**SUPPLEMENTARY REPORT TO THE JOINT REGIONAL PLANNING PANEL
(Sydney East Region)**

JRPP No.	2015SYE020
DA No.	DA-605/2014
Local Government Area	City of Canterbury-Bankstown
Proposed Development	Demolition of existing structures and construction of 2 x six storey mixed use buildings, with 5,973m ² of retail/commercial space, 297 residential units over 5 levels and 3 levels of basement car parking accommodating 684 car parking spaces
Street Address	1586-1598, 1600-1602, 1604 and 1606 Canterbury Road, Punchbowl (commonly known as 1600 Canterbury Road, Punchbowl)
Applicant	Urbanlink Pty Ltd
Number of Submissions	Nil
Recommendation	Approval with Conditions
Report by	Venetin Aghostin – Planner

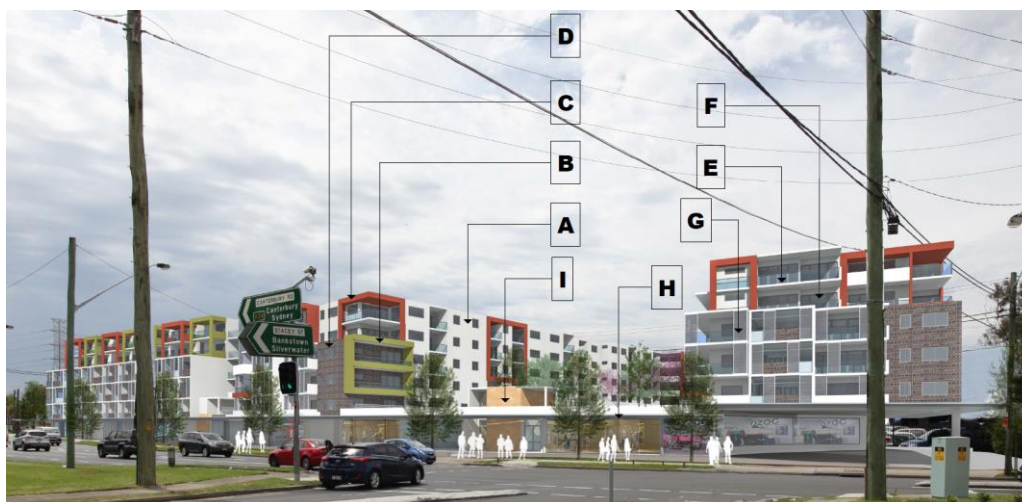
The Schedule of Finishes submitted on 19 July 2016 has increased the quality of construction materials and finishes. This was achieved by introducing new materials and reintroducing certain elements from the first version of plans originally lodged (i.e. elements that had dropped-off in subsequent versions of amendments).

Specifically, the following improvements have been made:

- i. Face brick (dark colour) has been extended across more elevations (including walls of ground floor shops) and replaces areas previously intended to be rendered and painted white/grey.

- ii. Sandstone wall tiles previously proposed to be used over walls of the ground floor shops has now been deleted, with these walls now to be face brick. The deletion of this material from the palette of finishes is acceptable and allows the palette to be limited to five complimentary finishes, instead of six.

- iii. Alucabond cladding (copper colour) has been introduced to replace areas (such as features framing balconies) previously intended to be rendered and painted with a Taubmaus red heart colour.

- iv. Alucabond cladding (copper colour) will also replace the parapets of ground floor shops which were previously intended to be rendered and painted white.

- v. Alucabond wall cladding (dark gray colour) has been introduced to replace walls of Levels 1, 2 and 3 previously intended to be rendered and painted dark gray.

- vi. Alucabond cladding (green colour) has been reintroduced to replace selected balcony balustrades previously intended to be rendered and painted white.

- vii. Extent of rendered and painted walls has been reduced since the above improvements. Applicant has explained that where render/paint will be used, the walls will be Hebel Panels with an acrylic finish (not a cement render) and painted off-white.

The amended plans have satisfactorily addressed the Panel's requirement.
